Florida Department of Transportation

May 7, 1999

This is in response to your April 16, 1999 letter received April 22, 1999 regarding the Tamiami Trail project feature of the U.S. Army Corps of Engineers' (the "Corps") Modified Water Deliveries to Everglades National Park Project.

FIGURE NO.

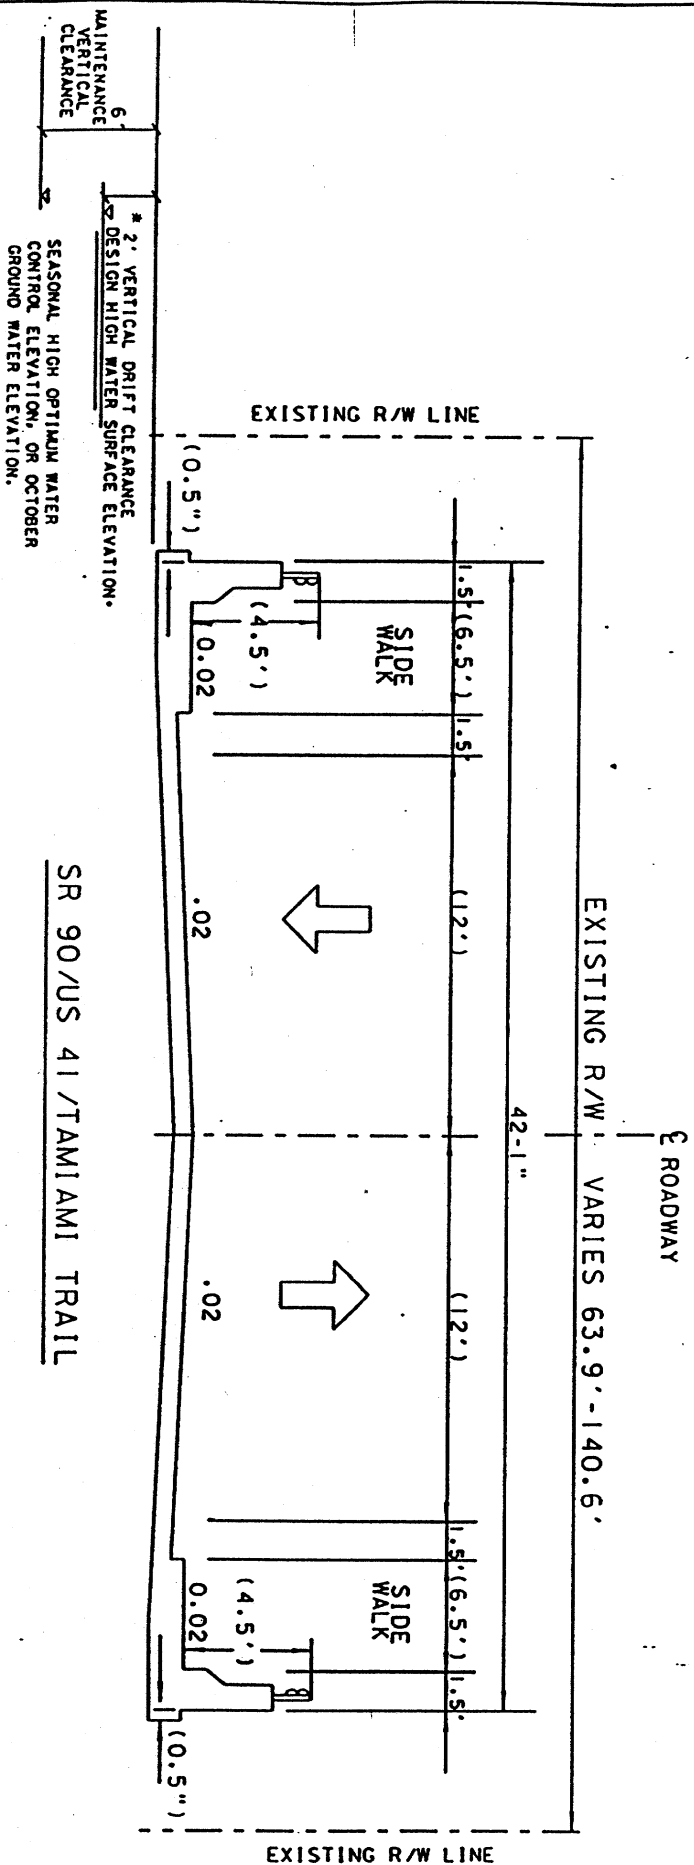
4) Waiver request by the Corps to reduce the two-foot bridge drift clearance to a one-foot bridge drift clearance:

We concur in the reduction of the bridge drift clearance from two feet to one foot for purposes of conceptual alternative development. This clearance will be measured from the design high water elevation to the bottom of the lowest superstructure member. The design high water elevation needs to be established for each conceptual alternative. For the purposes of determining bridge clearances and openings the design high water will be the expected water elevation resulting from a 75 year recurrence interval (4,000 cfs flow). This reduction does not account for any clearance requirements that may be imposed by the South Florida Water Management District (SFWMD). The bridge drift clearance will be reevaluated for the recommended design alternative prior to final approval. The expected water velocity and the potential for debris impacting the superstructure will be part of the evaluation of the recommended design. If the clearance can be reasonably increased, up to the desirable clearance, with minimal economic and/or environmental impacts, you may be asked to review the design to provide increased clearance.

Since bridge drift clearance standards must be approved in this case by both the Department and the SFWMD, we recommend you contact SFWMD for their opinion. For preliminary considerations, as long as the velocity in the canal during the maximum design flow event at the proposed bridge location is at or under 2.5 feet per second (fps), and the type of floating debris does not cause damage to the lowest member elevation of the bridge structure, then the request may be considered for a waiver by the Department. It should also be noted, however, that the other vertical clearance which must be met is the six-foot navigation vertical clearance necessary for maintenance of the canal and the bridge structure. This six-foot vertical clearance should be above the normal water surface elevation, or the October ground water elevation.

Please reference the enclosed typical section demonstrating bridge drift clearance.

* VERTICAL DRIFT CLEARANCE
MAY BE REDUCED TO 1' IF
S.F.W.M.D. AGREES WITH THIS
WAIVER REQUEST.

FLEXIBLE PAVEMENT DESIGN SUMMARY SHEET
Preliminary , subject to change

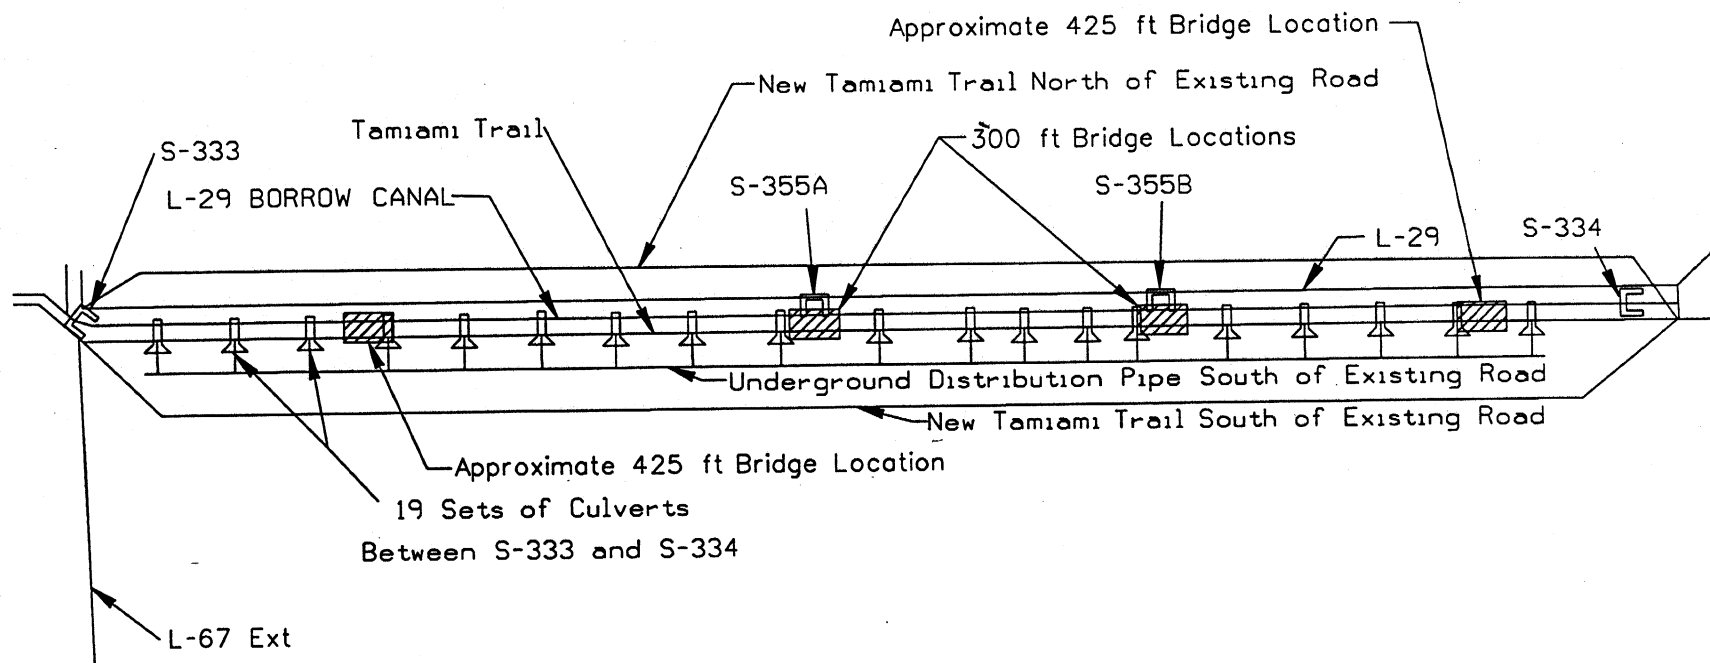
The enclosed pavement design sheet is based on having the proposed alignment (i.e., footprint) in exactly the same location as the existing. It proposes to use the structural number (SN) of the existing roadway plus a minimum of four inches of Type S asphalt which may vary up to a 12.4 inch thickness. Added to this would be a two-inch thick structural course (shown as "SP" on the attached pavement design sheet) and finally a ¾-inch thick friction course. However, the entire friction course of the existing roadway would have to be milled (one inch) before the proposed layers are placed. If there is a need to realign the roadway (i.e., shift it's existing location), this pavement design could not be used. A different design somewhat more expensive would then have to be prepared.

Based on the design high water elevation provided by the Corps of 9.5 feet NGVD (derived from the occasional 4,000 cfs flow), a minimum profile grade elevation at the roadway crown of 12 feet would be required.

9.50 (DHW)+1ft Clearence+1.5 ft(Pav't tk.+cross slope=12.0 Ft NGVD
It means raise the Road from 0 to (12.0-10.3) 1.7 Ft= 20.4 inches

SN
Existing pavement	3.99
Type S overbuild(4" to 12.4") (400 to 1240 lb/sy)	0.00
OBG 9 *	1.80
Type 'SP' Struct.Cse.(Level 3) 2" tk	0.44
FC5-Friction Course, (80lb/sy), 3/4"tk	0.00
	0.00
Design SN	6.67
